M645 SUPER

2 CAMERA BODY

7 TECHNICAL BULLETIN

| NEW S. BUTTON GUIDE | 1/1 | 76 | 10 |

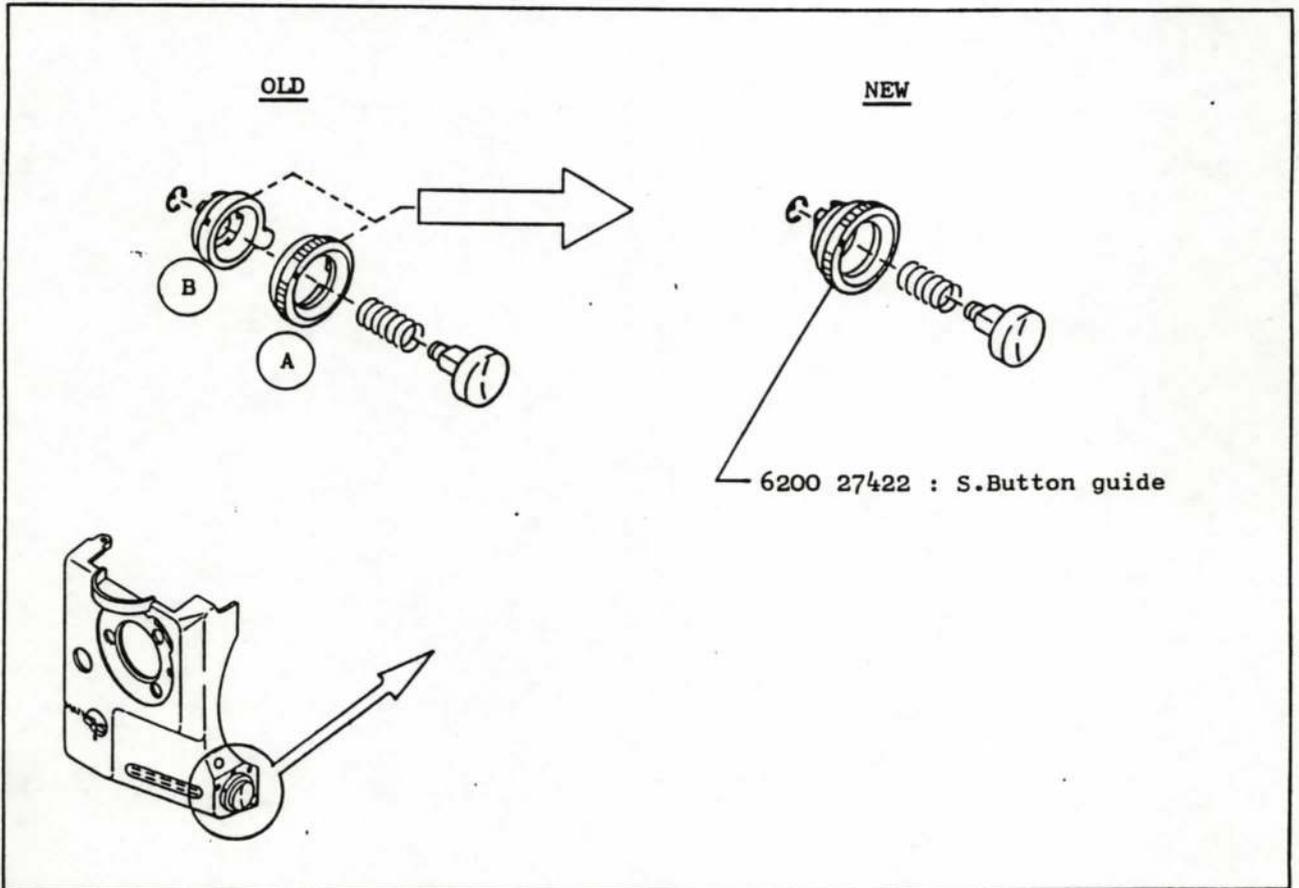
The (A) and (B) parts of the S.Button guide has been modified in a unit part to avoid dropping out of (A) parts.

Modification Date : Since 1987 October.

1. Old New Parts Interchangeability :

| NEW ANGEL PLATE | 1/1 | 76 | 8 |

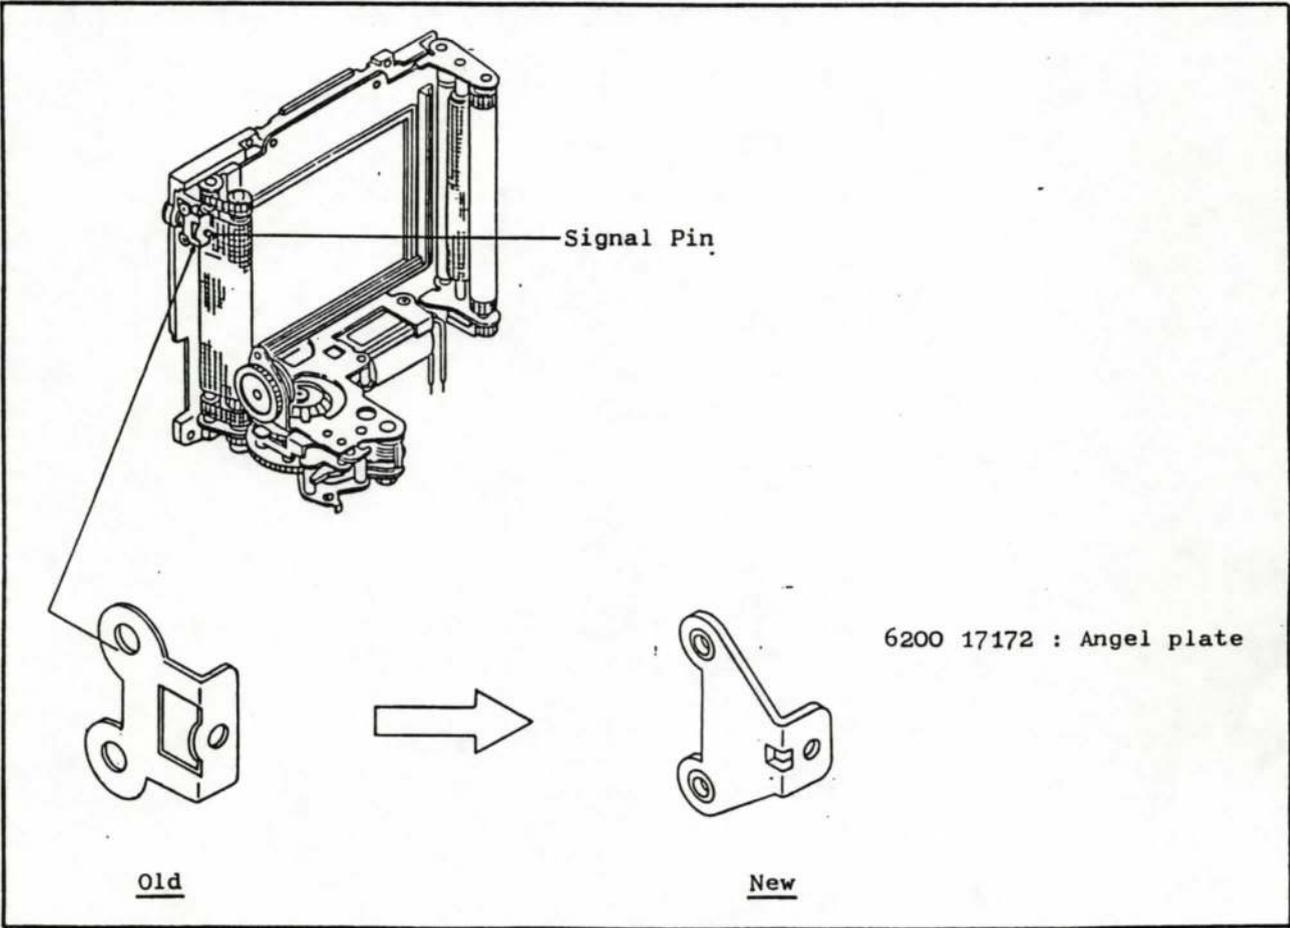
Phenomenon : Signal Pin do not operate properly.

Modification : Shape of Angel plate.

Modification Date : Since 1987 May Production.

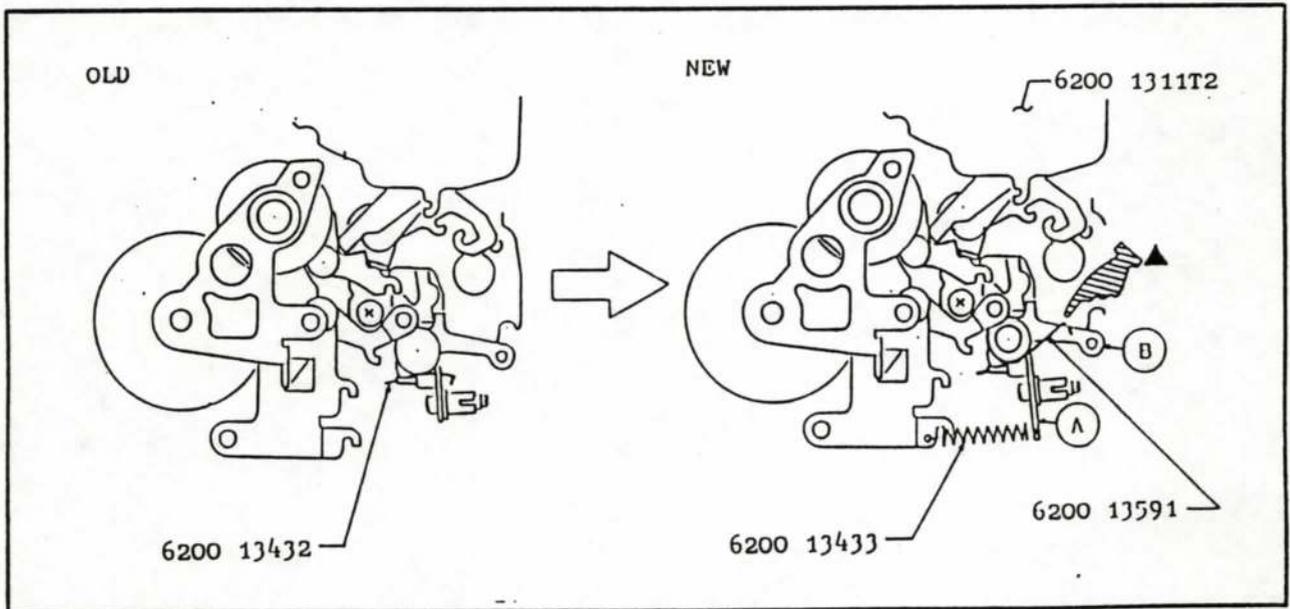
Phenomenon : When winding crank is wound, suddenly mirror is released and stays at upper position.

Cause : Lever A and B do not operate properly.

Modification : 1) An additional new spring : 6200 13432  
2) Change of spring shape and its fixing position.

Modification Date : Since 1987 March production.

REPAIR FOR MIRROR LOCKED UP

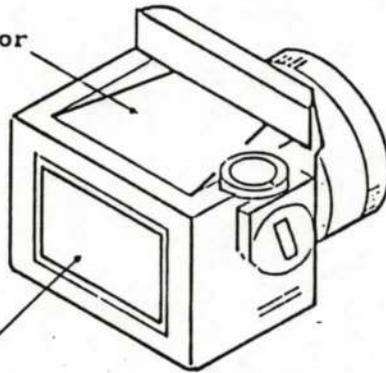
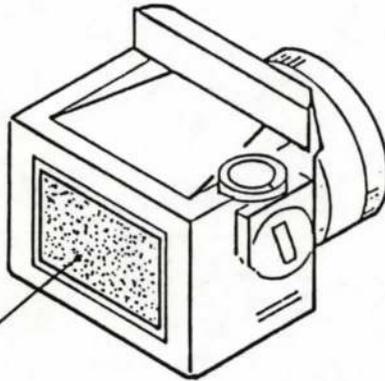
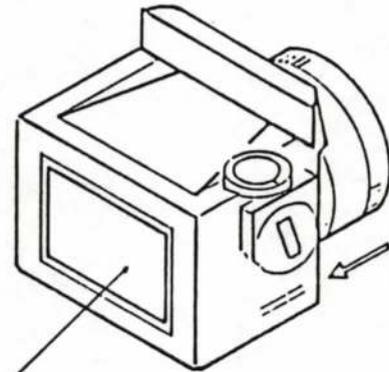
Phenomenon :

A When wound up, mirror does not return and stays at risen position.

A' As same as above A

Cause :

1) Improper adjustment of the mirror release lever.

Phenomenon :

B After released, mirror does not return and stays risen position.

Cause :

- 1) Shutter curtain ribbon was teard off.
  - \* If the second shutter curtain of the mechanical shutter release does not function, the cause should be that the shutter curtain ribbon is off.
- 2) Dirty spring of the trigger switch and improper contact pressure. ( proper contact pressure : 30g)

# REVISED

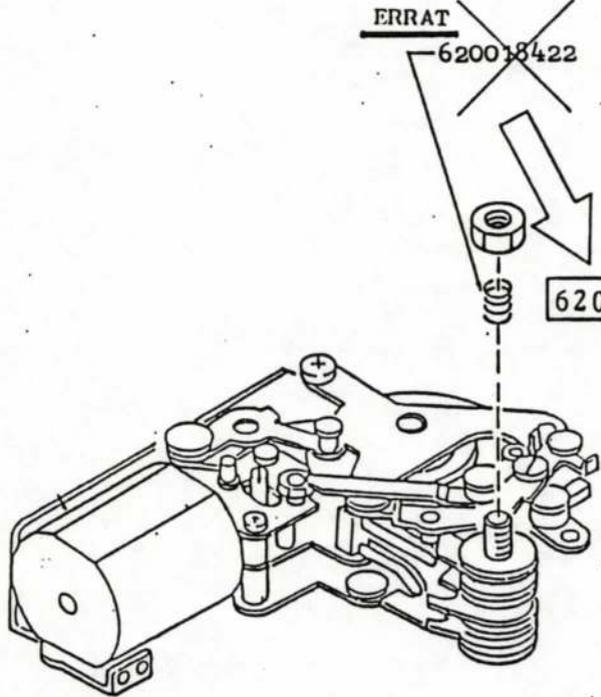
: To facilitate adjustment of 1st curtain bounce the spring has been changed as shown in the drawing.

: Quite same step with repair manual page 36

: From August, 1986.

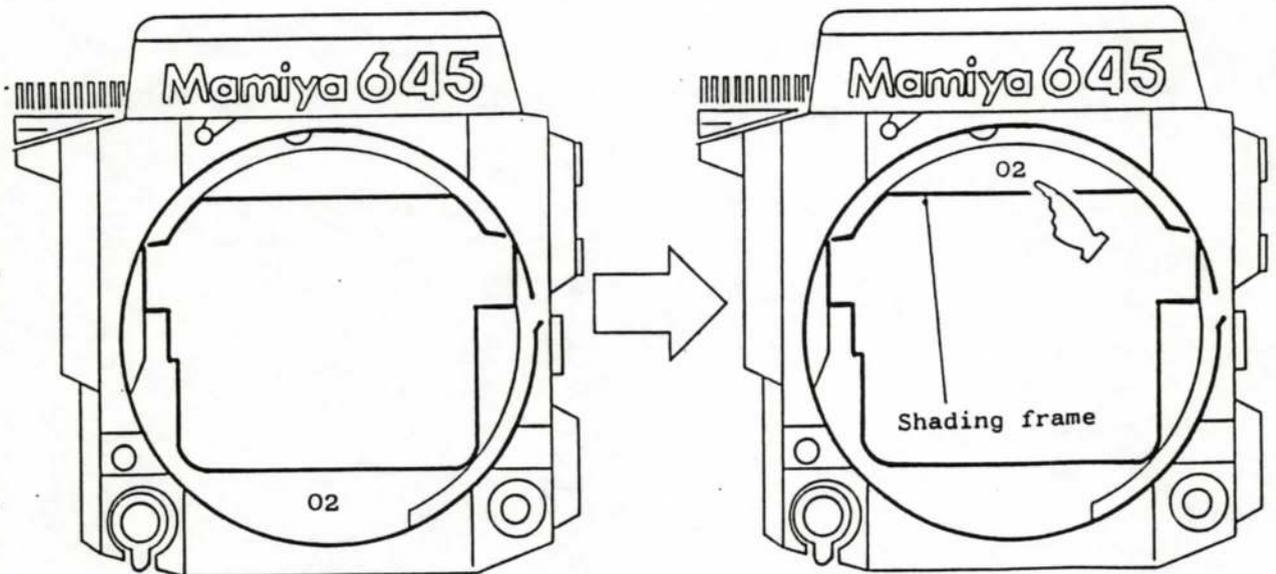
1. DISCRIMINATION : Modified body is still marked with "02" stamp.  
"02" stamped on the upper part of body front shown in to drawing below.
2. MODIFICATION DATE : From middle of October, 1986.

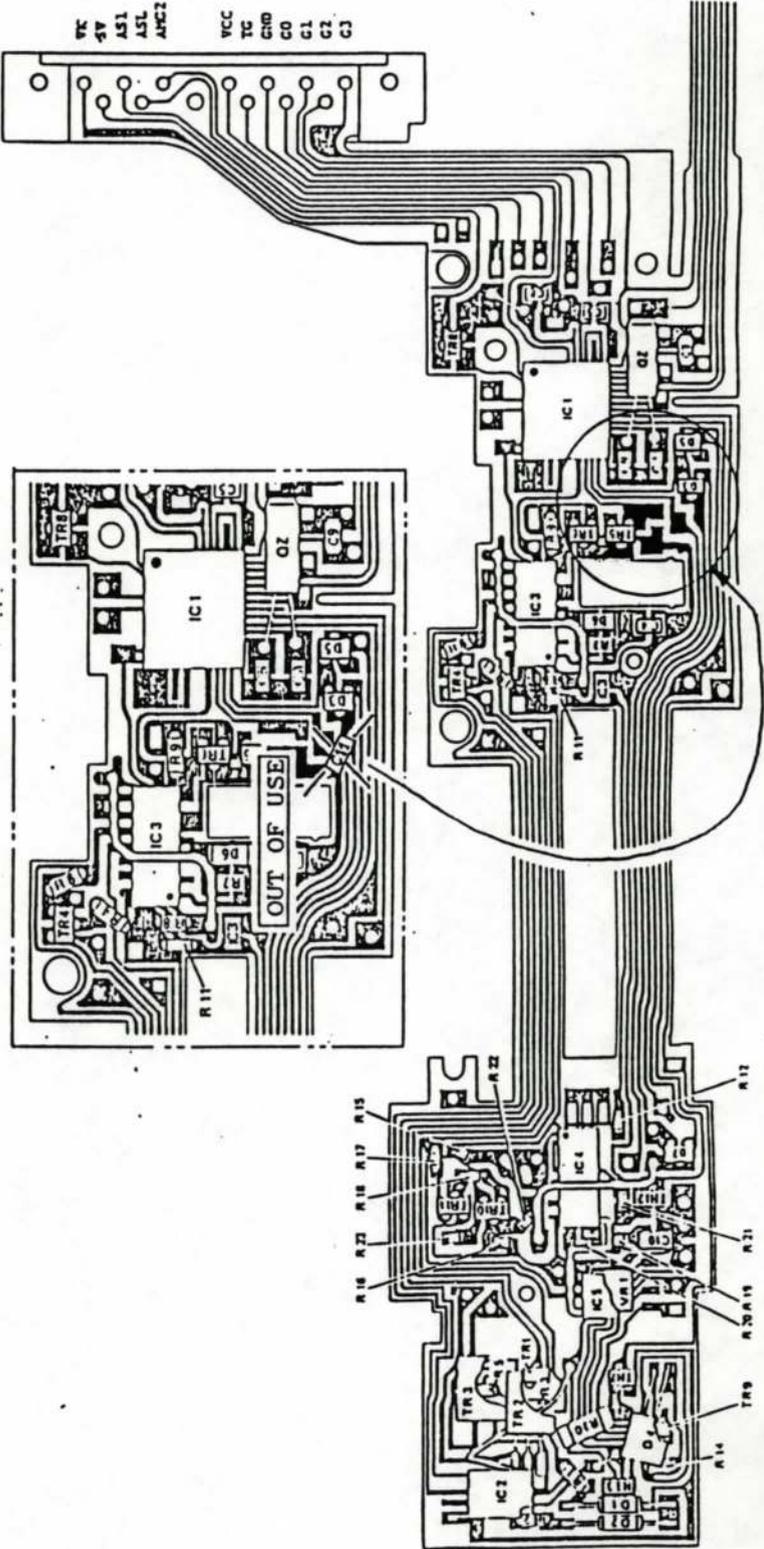
- 1. PHENOMENON : After completion of winding up with power drive, again move the selector lever of power drive to start position sometimes release shutter dose not work.
- 2. MODIFICATION : Take off C11(0.1μF 15v) condenser from Main F.P.C board.
- 3. MODIFICATION DATE : From May, 1986.

## SHUTTER CURTAIN RIBBON

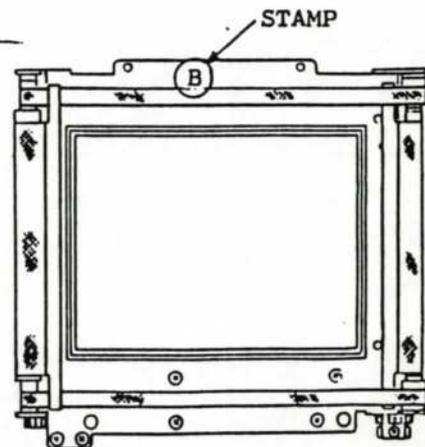
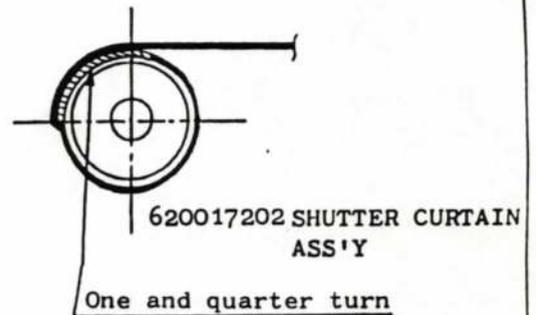
PHENOMENON : The curtain ribbon was teard off.

MODIFICATION : A longer curtain ribbon is used to increase the bonding area and adhesive strength.

MODIFICATION DATE : From October,1986.

Modification mark of shutter curtain : "B" stamp on the shutter base plate.

MIRROR NOT RETURN

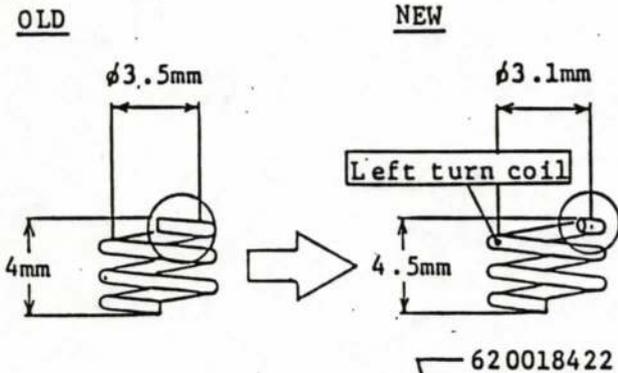
: MIRROR does not return even if 2nd curtain closes completely.

- : (A) mirror release lever does not kick
- : (B) mirror-up lever properly

: Carefully bend the tip of (A) lever.

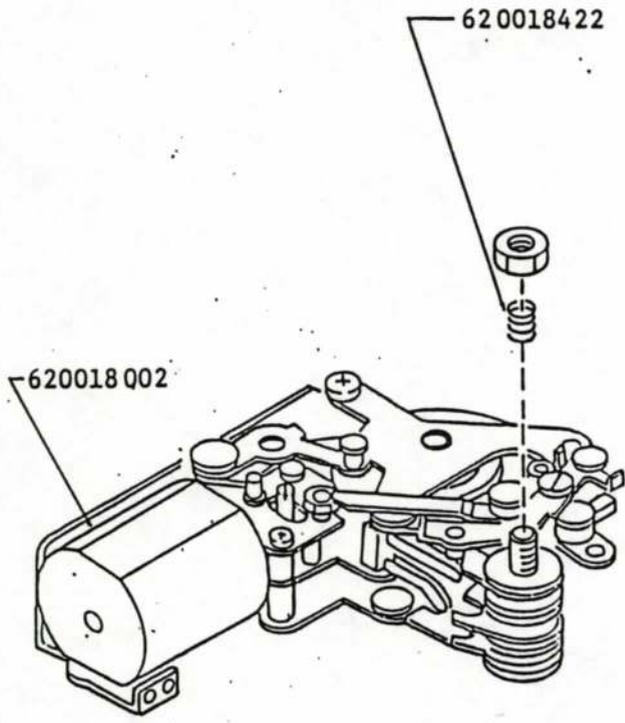
: To facilitate adjustment of 1st curtain bounce the spring has been changed as shown in the drawing.

: Quite same step with repair manual page 36

: From August, 1986

NEW SPRING FOR SHUTTER RELEASE LEVER

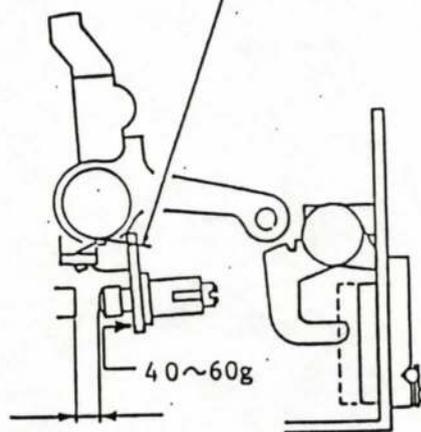
: The mirror does not return and stays at risen position.

: 2nd curtain does not run because 620013431 spring of S-lever does not work adequately.

: Shape of spring 620013431 → 620013432

NEW 0.2~0.3mm

OLD 0.1~0.2mm

: Replace the spring with new one.

Note) After replacement of the spring adjustment of shutter release lever is required by referring Repair manual page 40- (A).

please note that the tolerance of adjustment was changed as shown in the drawing.

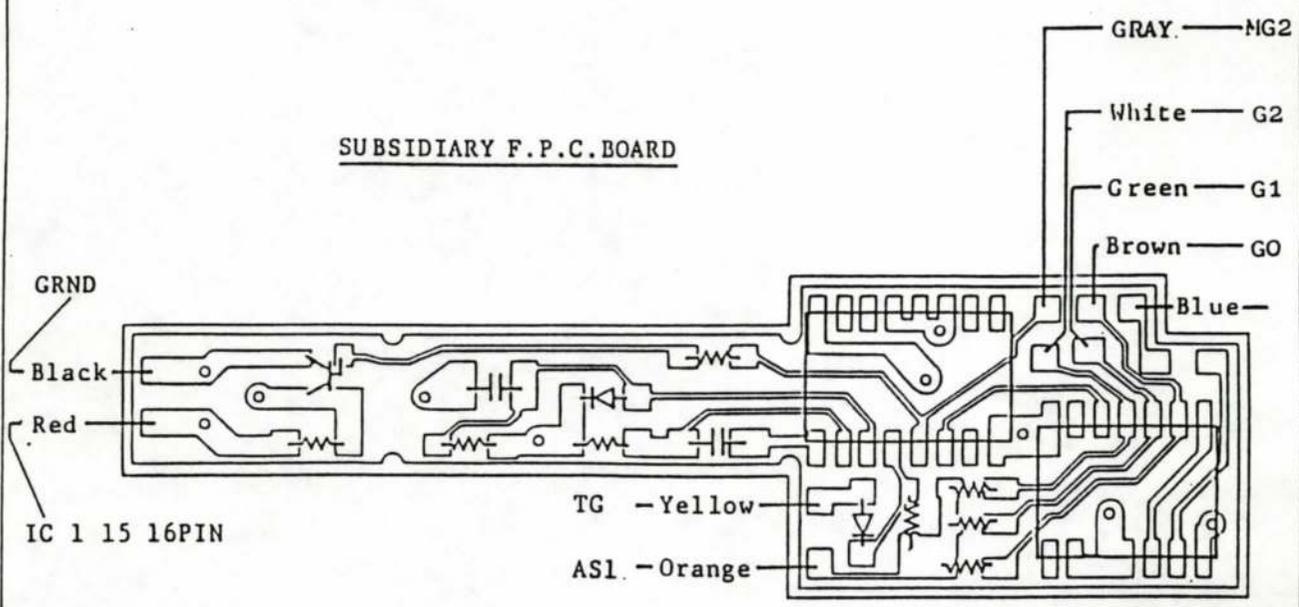
: If the flash duration of an electronic flash is longer than 1/1000sec, vignetting may be caused on the exposed flash when shutter is released at 1/60 sec.

: Install 620033261 sub-F.P.C.board into the main F.P.C.board.

: From October production 1986.
